# Recall Bulletin

## PRODUCT SAFETY RECALL

**SUBJECT:** Lapbelt Pretensioner Locking Performance

**MODELS:** 2013 Buick Encore  
2013 Cadillac ATS 4-Door  
2013 Chevrolet Trax  
and  
Vehicles that were serviced with a suspect part:  
2013-2014 Buick Encore  
2013-2014 Cadillac ATS 4-Door  
2014 Cadillac CTS Sedan (VIN A)

3966508

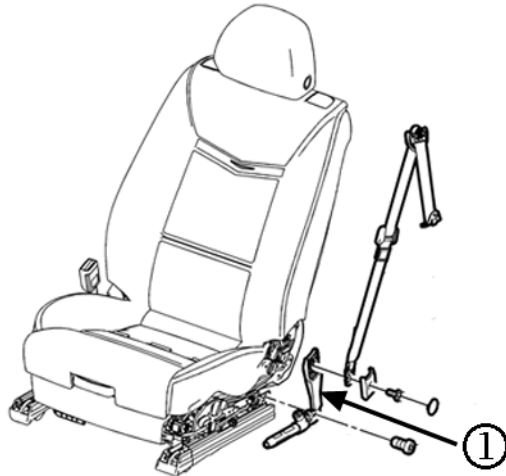
Dealers are to replace both front outboard lap belt pretensioners.

1. Remove the driver and passenger seat belt tensioner assemblies (1). Refer to *Front Seat Belt Anchor Plate Tensioner Replacement* in SI.
2. Install new driver and passenger seat belt tensioner assemblies. Refer to *Front Seat Belt Anchor Plate Tensioner Replacement* in SI.
